Appendix I Road Safety Audit

DEPARTMENT OF STATE GROWTH

**HOBART CITY DEAL
SOUTHERN
PROJECTS
SUB-PROJECT 1:
SOUTHERN OUTLET
TRANSIT LANE
CONCEPT STAGE
ROAD SAFETY
AUDIT**

Figure C.1 Davey Street Pedestrian Crossing

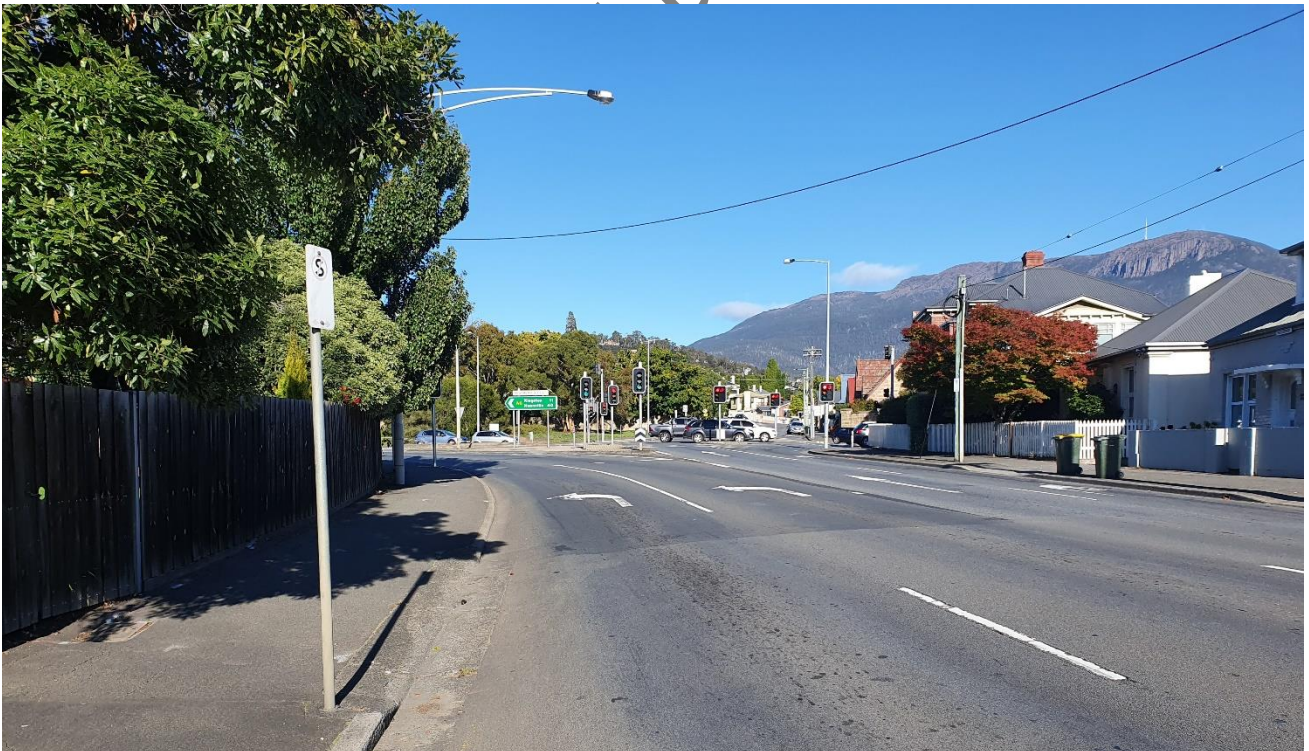
2.1.	The traffic signals on the approach to the Southern Outlet only turn red when a pedestrian presses the button to cross which is reasonably infrequent. Sight distance on the approach to the crossing is also relatively poor. The combination of these two factors creates potential for pedestrian crashes due to drivers travelling through the red light	Pedestrian crossing should be upgraded to provide improved pedestrian safety. This could be undertaken in the form of upgrading the pedestrian crossing to a raised treatment, or via the provision of a grade separated pedestrian crossing. Additional signage prior to the crossing should also be introduced to warn drivers of the approaching crossing.	Occasional	Serious	High	Yes	A raised treatment would be undesirable here given the high volume of heavy vehicles, including trucks and buses. Concept design has been adjusted to improve safety where possible. Issue captured in the risk register for further consideration during detailed design.

Figure C.27 Davey Street Uncontrolled Pedestrian Crossing

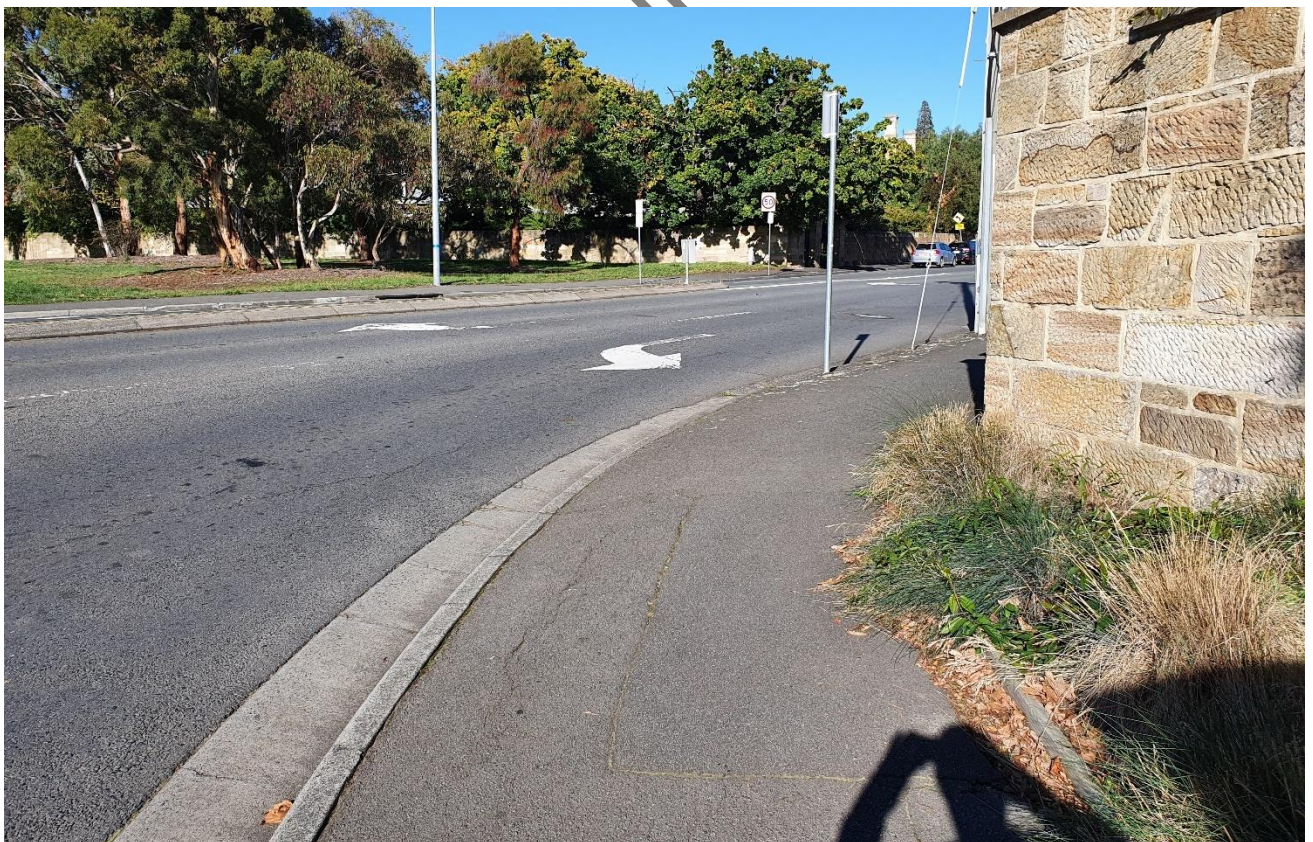
3.13.	Other than the provision of pram ramps, no formal pedestrian crossing facilities exist at the Davey Street and Southern Outlet intersection for the slip lanes located on the south-west and north-west corners. Sightlines on the northern side of the intersection are also compromised. This may lead to potential vehicle and pedestrian collisions.	Provide formal pedestrian priority (zebra crossing) treatment with signage. Consideration to be given to installation of raised safety platform.	Probable	Serious	Intolerable	Yes	Intersection is being upgraded
